**ANYTHING BUT  
AVERAGE**

**STRICTLY  
TECHNICAL**

INDEX.PAGE.

FIG. 1 - V8. The cable is fitted between the large alternator terminal and the positive battery lead terminal.

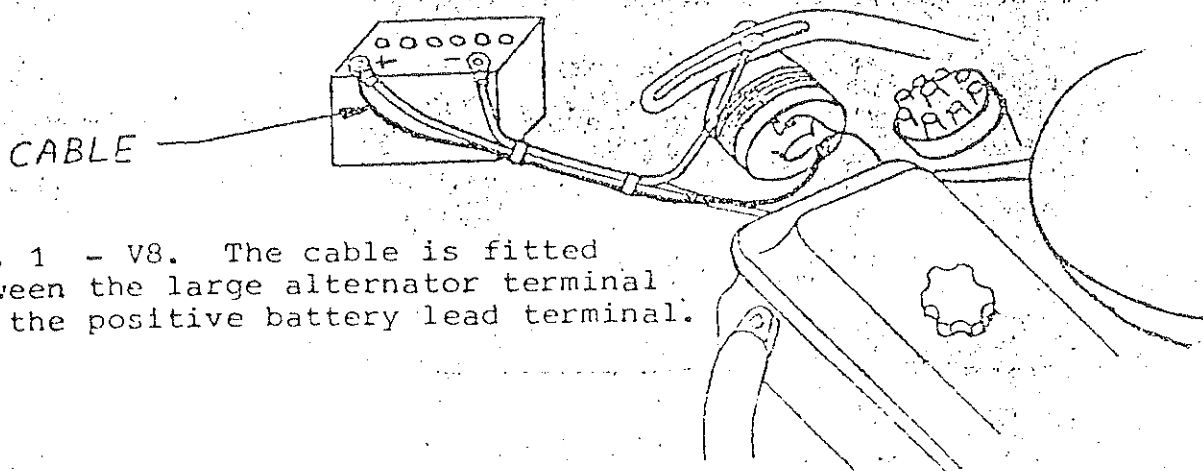
When driving at night with headlights on, the ignition warning light may glow faintly. This is due to a voltage drop between the alternator and battery. To rectify this, fit an additional cable as shown in figures one, two and three.

FIG. 3

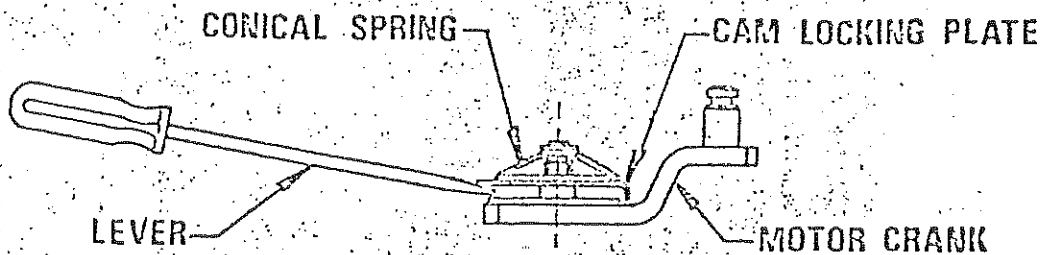
1) Partially remove the rubber boot at the base of the wiper motor and observe the cam follower Plate below the conical spring.

2) Refer to FIG 3 and correct the 'out of square' condition with a screw driver Placed between the cam locking Plate and the motor crank. Lever upwards until the Plate drops freely into the locked Position with the motor crank.

### STEERING COLUMN LOCK WIRING

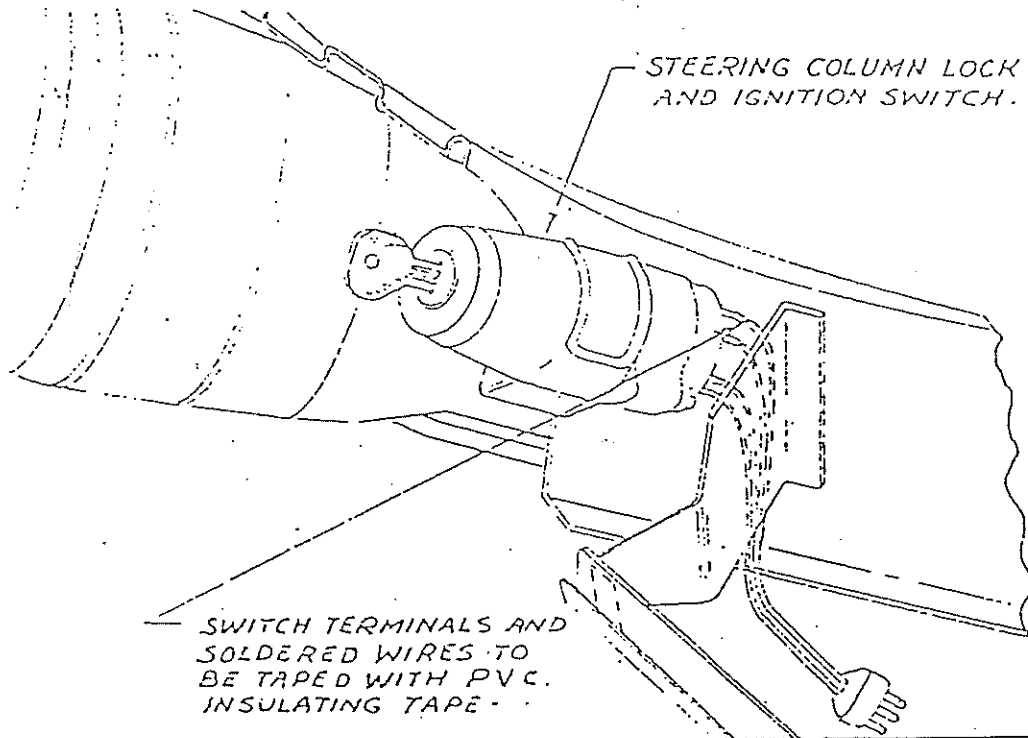
A condition can exist on early production vehicles where there is inadequate clearance between the fascia bracket and the wiring at the base of the lock. See Fig.2. All early production vehicles should be inspected to see that adequate clearance exists in this area. If the clearance is inadequate, the fascia bracket should be bent, or, alternatively, the wiring loom and switch terminals should be taped to prevent chafing and consequent short circuit or fire hazard.

### DOOR SWITCHES

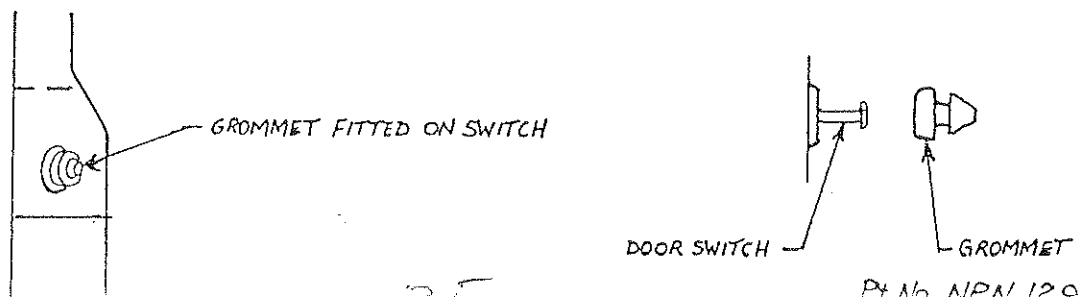
A similar problem to the above can occur with the courtesy lamp switches in the doors. Insufficient travel of the plunger allowing interior lamps to flicker or stay on. This can be rectified by the addition of a medium sized body grommet fitted to the switch as illustrated.

## HEADLIGHT SWITCH

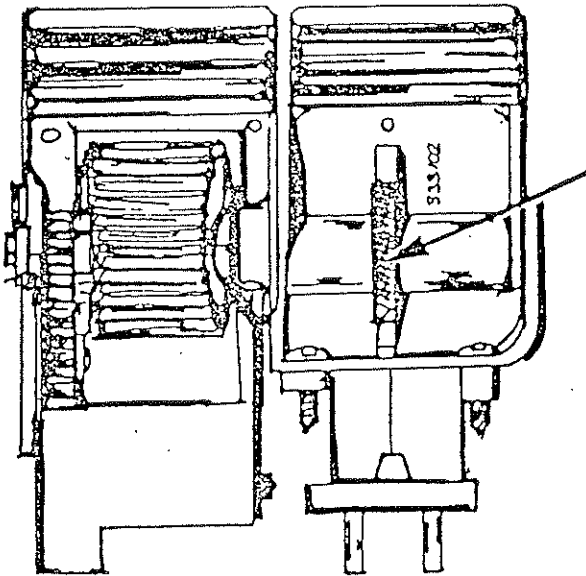
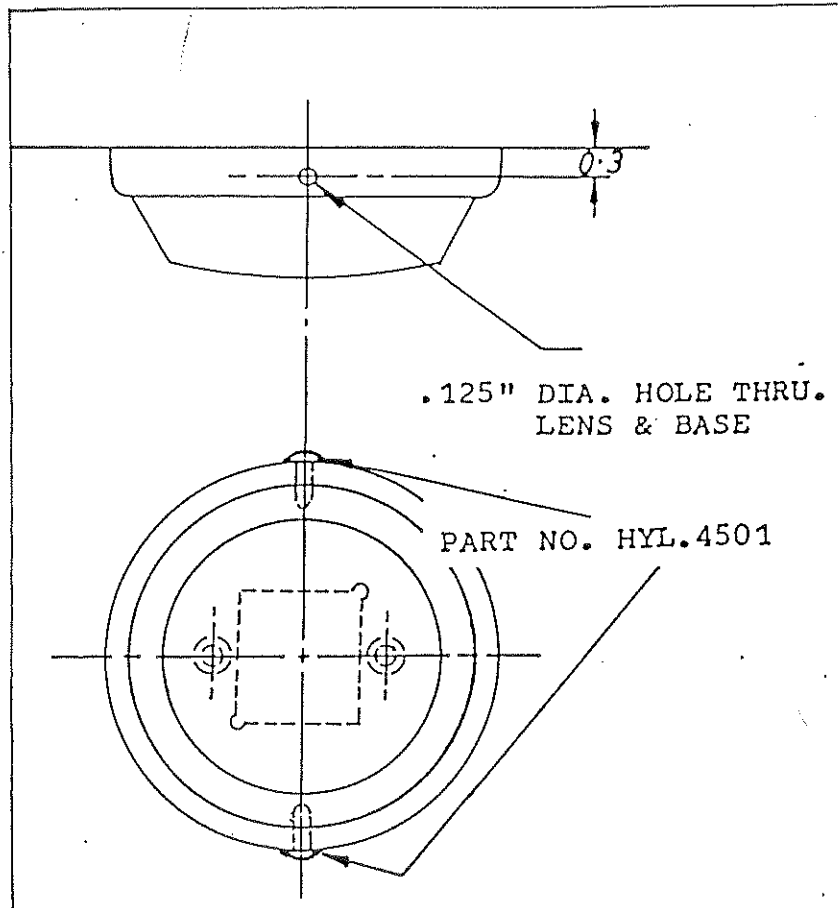
It has been found that over-travel of the switch when in the headlight position is a major cause of the headlights flickering or going out.

This can be rectified by interposing sufficient cork gasket material between the switch stop and bracket to eliminate the free play. Refer sketch. The gasket material should be secured with 3M .1099 or pliabond. Additionally it is important to ensure that the moulded plug is secure on the pins at the rear of the switch and that the main and dip beam fuses are tight in the holder.
